FIELD REVISION SHEET
THIS SHEET SUPERSEDES SHEET 487

I-81 VIADUCT (COMMUNITY GRID) - CONTRACT 3
CITY OF SYRACUSE
OSWEGO BOULEVARD, SH C56-11
BEAR ST, SH C59-4
COUNTY: ONONDAGA REGION: 03

DRAINAGE AND UTILITY PLANS
N. CLINTON ST
AND GENANT DR

CONTRACT NUMBER D265218

DRAWING NO. DUP-12
SHEET NO. 497R1

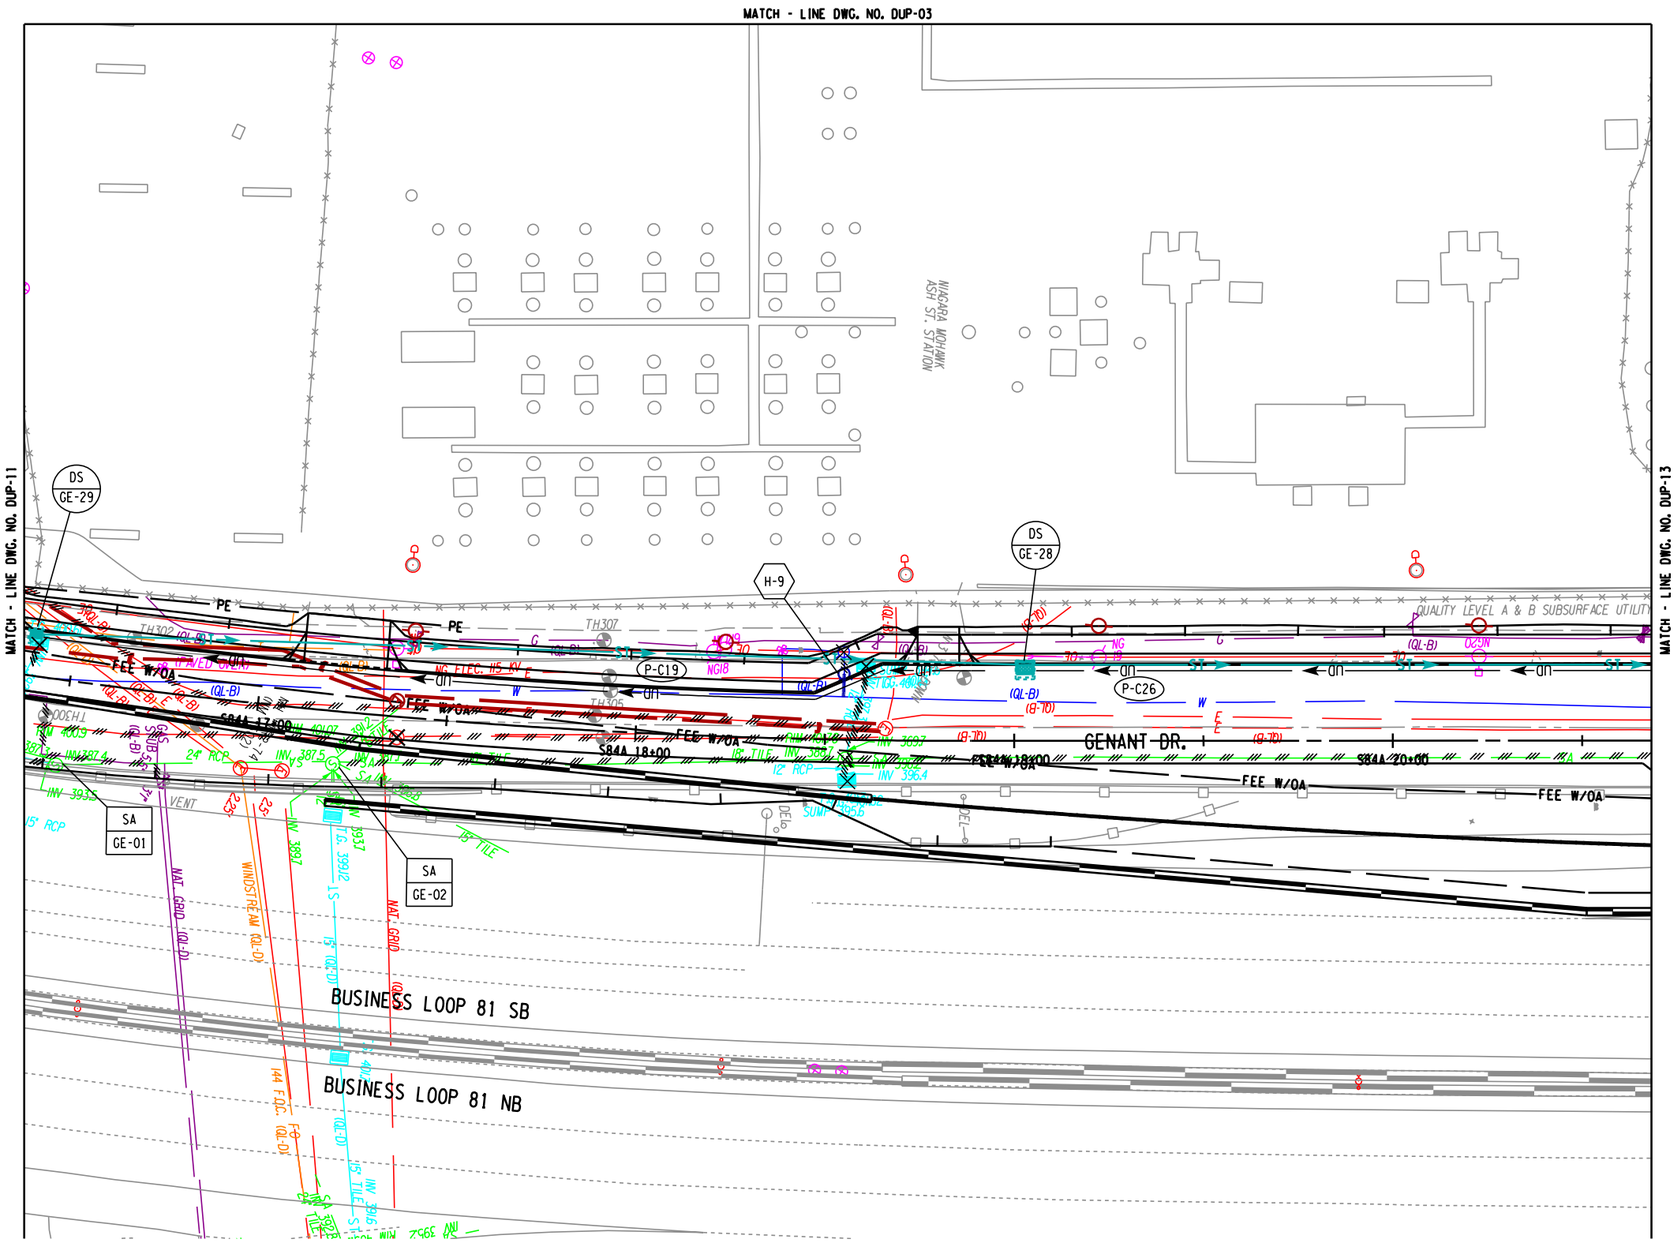
1. ADDITIONAL WATERMAIN ADDED FOR DIVISION ST STARTING FROM LOCATION 177 TO LOCATION 198

2. PROVIDED NEW LOCATION OF WATERMAIN TO BE REMOVED.

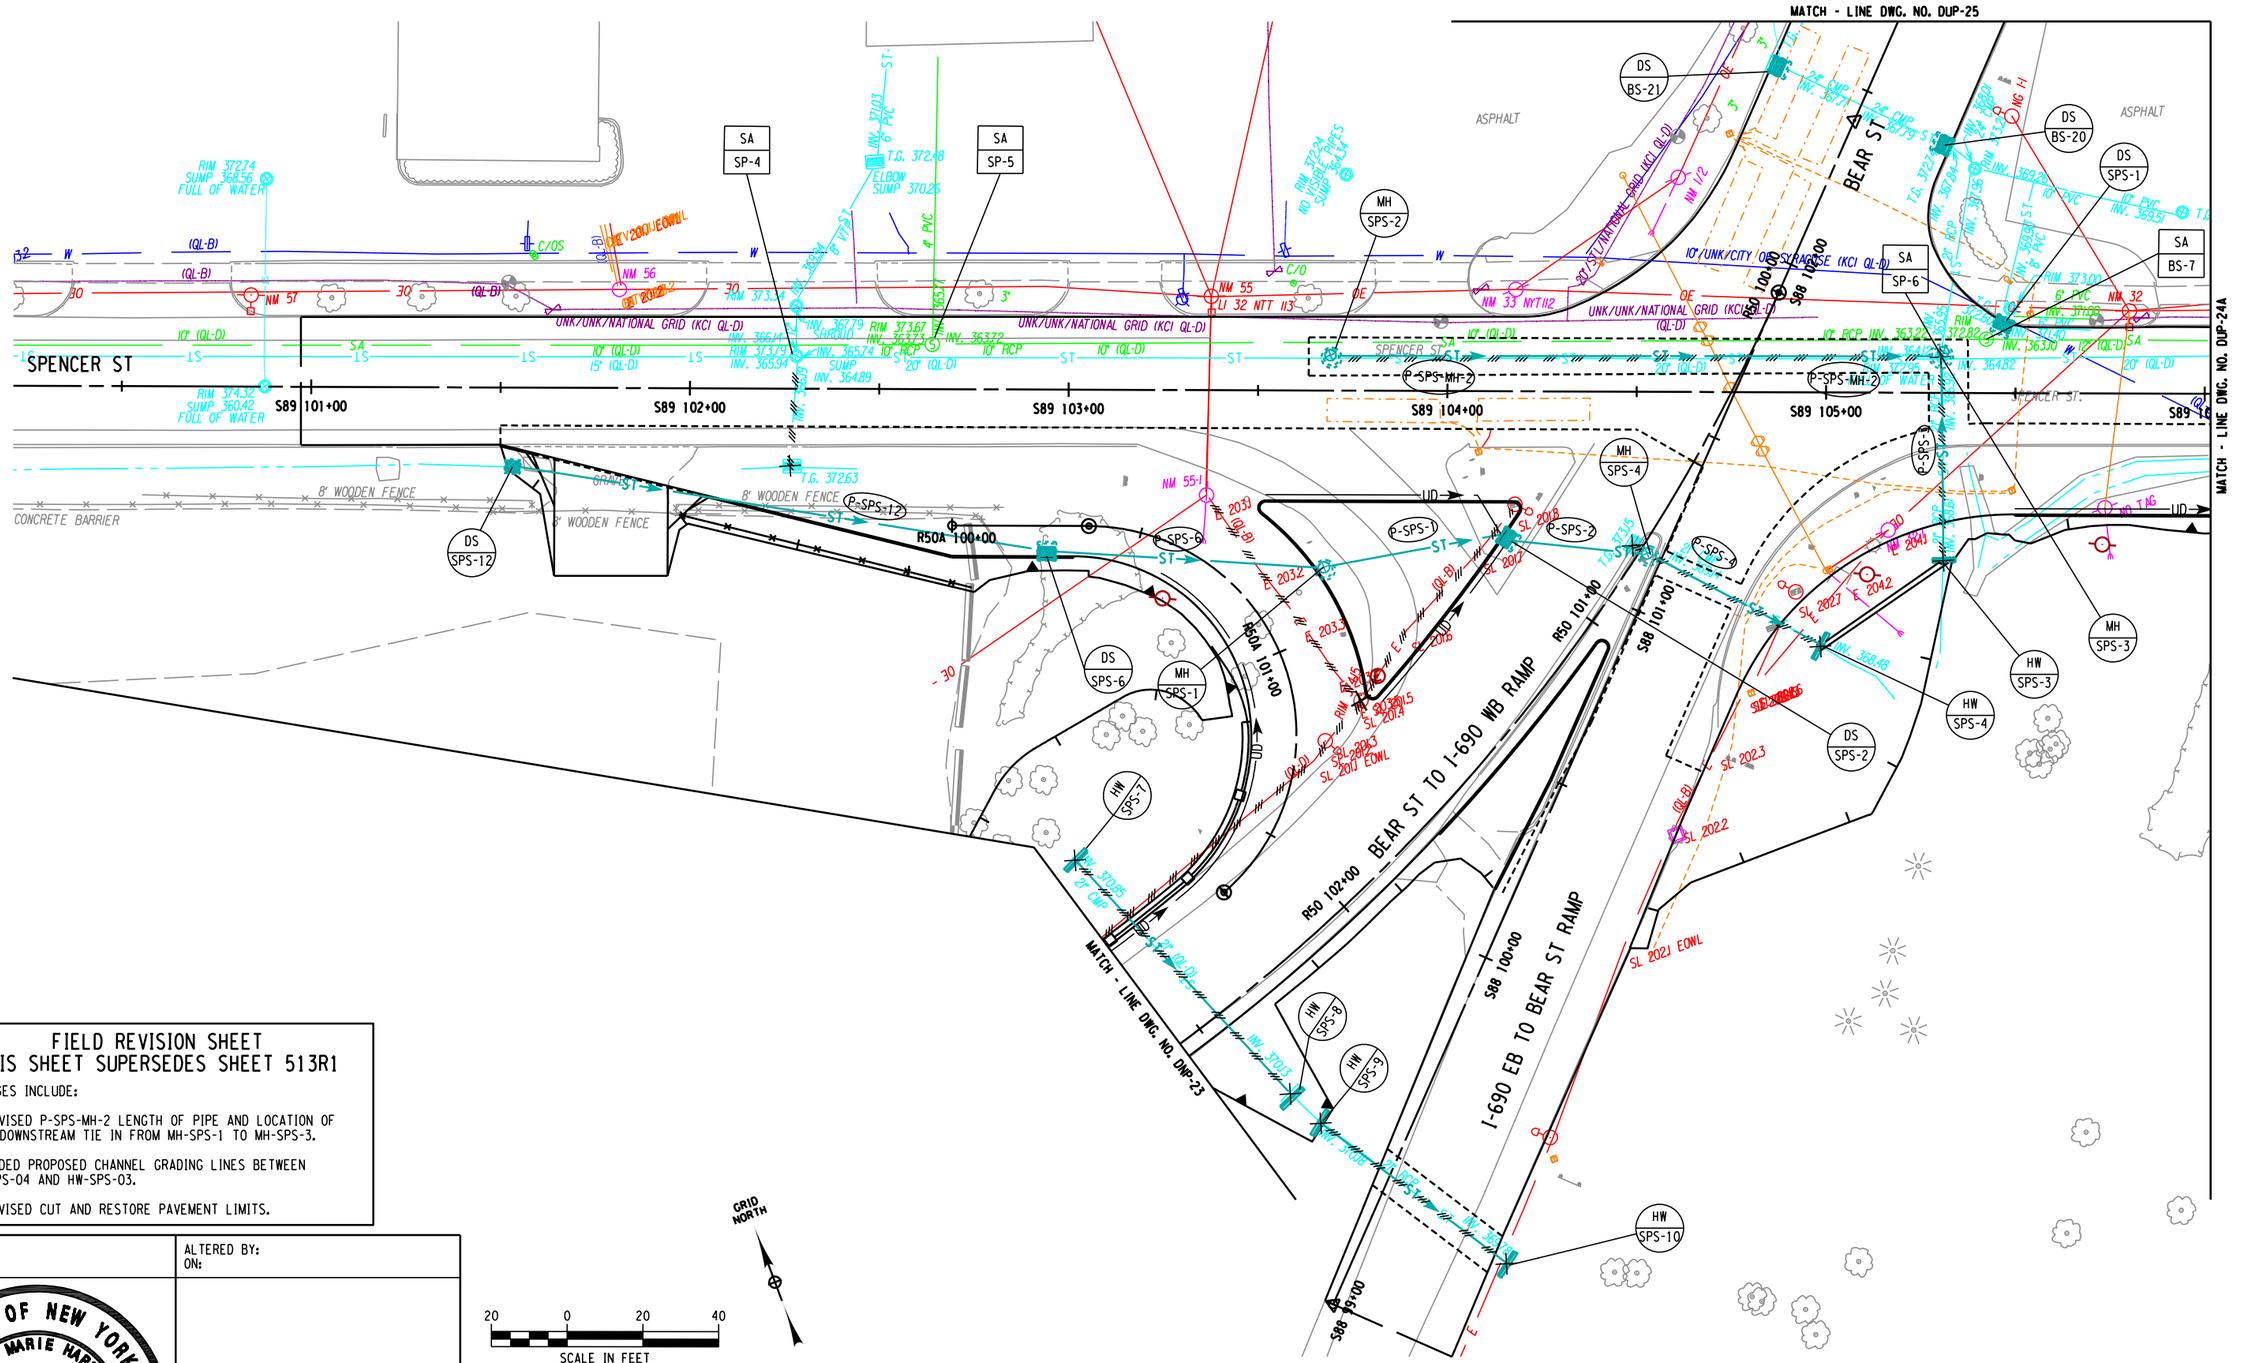
1. REVISED P-SPS-MH-2 LENGTH OF PIPE AND LOCATION OF PIPE DOWNSTREAM TIE IN FROM MH-SPS-1 TO MH-SPS-3.

2. ADDED PROPOSED CHANNEL GRADING LINES BETWEEN HW-SPS-04 AND HW-SPS-03.

3. REVISED CUT AND RESTORE PAVEMENT LIMITS.

DRAWING NO. DRP-04
SHEET NO. 531R2

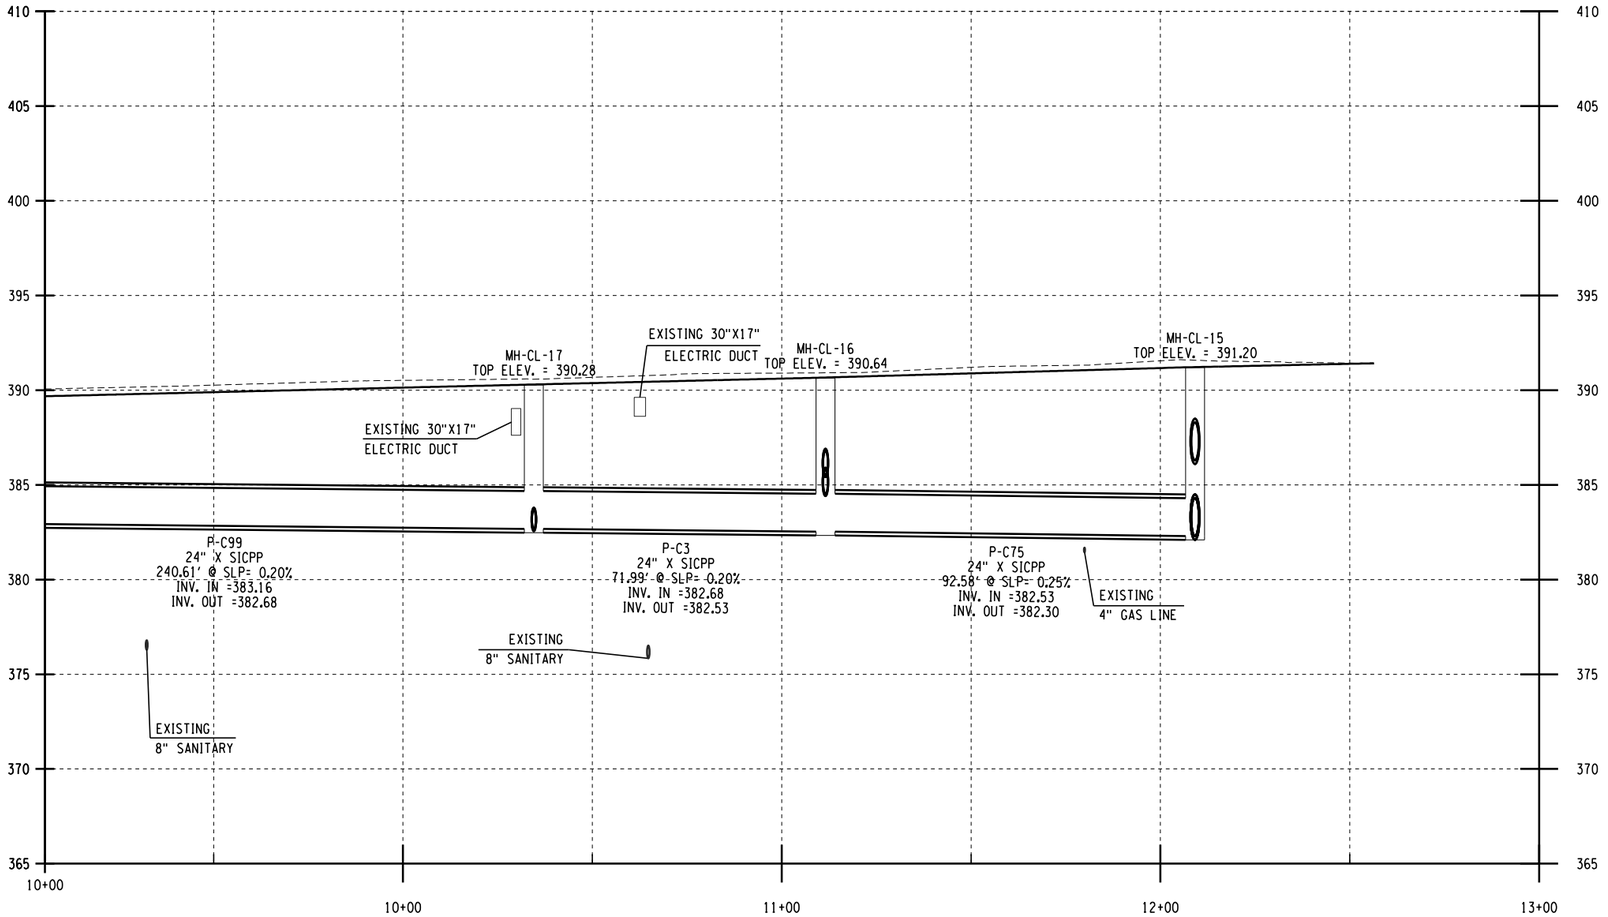
1. REVISED DOWNSTREAM INVERT AND SLOPE FOR P-C33.
2. MOVED MH-CL-22 AND MH-CL-17
3. CHANGES TO P-C99, P-C3, AND P-C119.

DRAWING NO. DRP-23
SHEET NO. 550R2

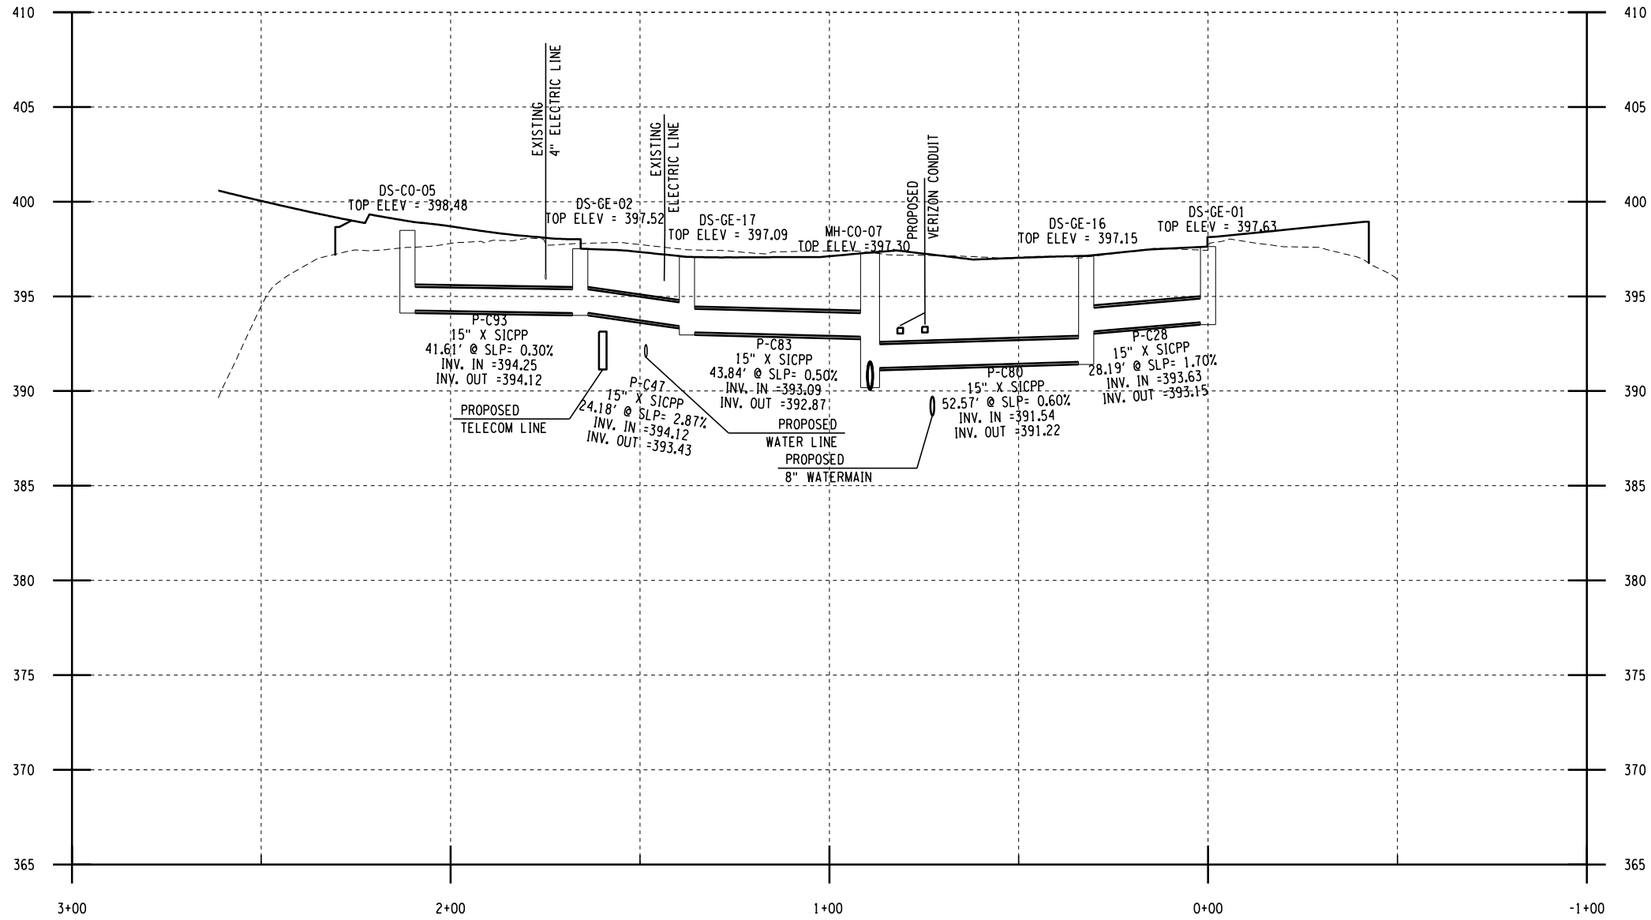
1. REVISED INVERTS AND SLOPE FOR P-C28.
2. REVISED INVERTS FOR P-C83.
3. REVISED DOWNSTREAM INVERT, SLOPE, AND LENGTH FOR P-C47.

DRAWING NO. DRP-24
SHEET NO. 551R2

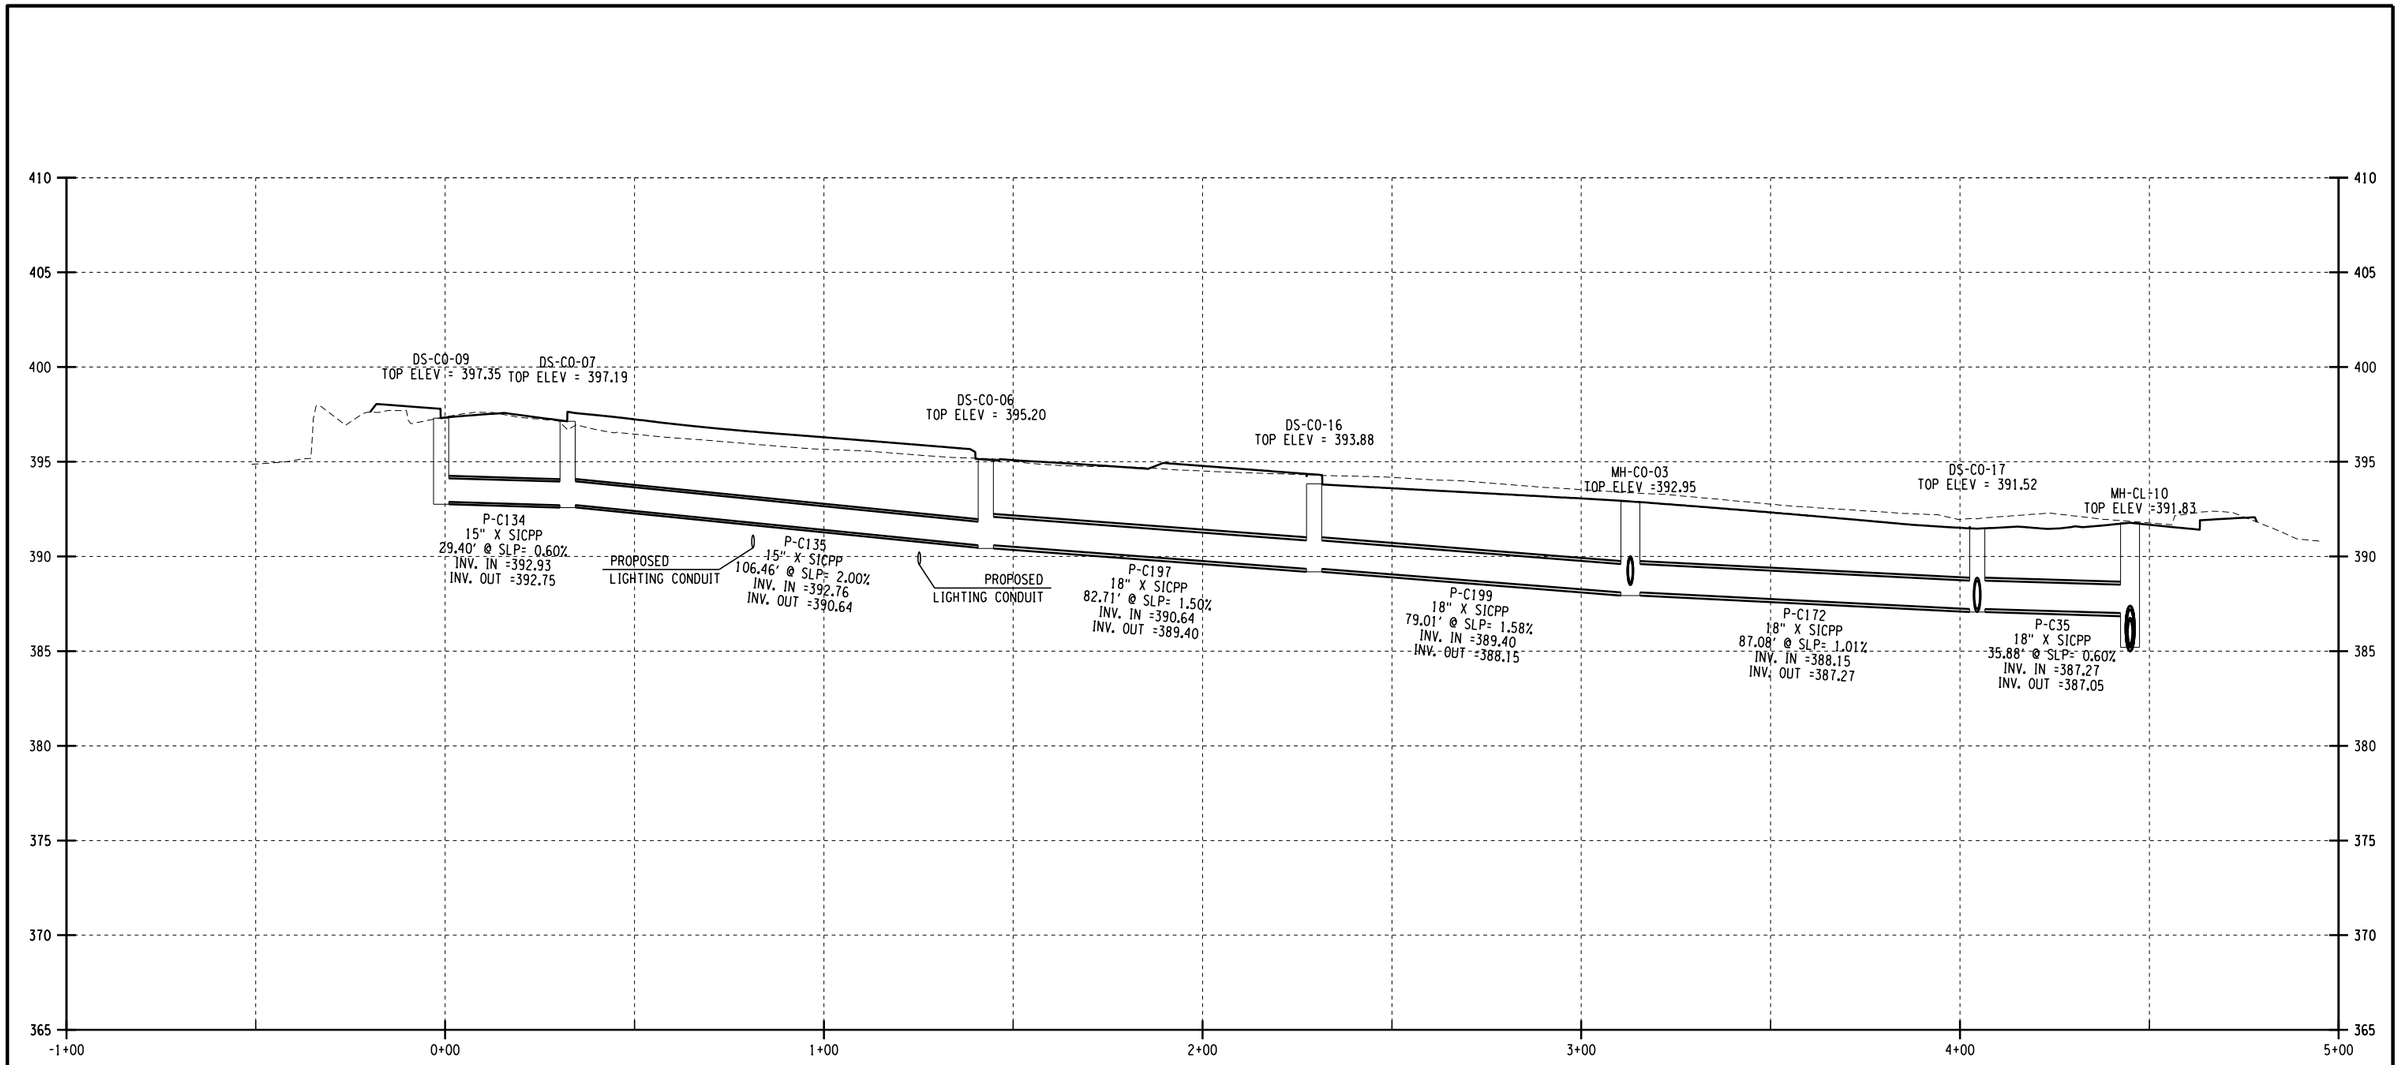
1. REVISED LENGTH OF PIPE FOR P-C134, P-C135, P-C197, P-C199, P-C172, AND P-C35
2. REVISED DOWNSTREAM INVERT AND SLOPE FOR P-172.
3. REVISED INVERTS FOR P-C35.
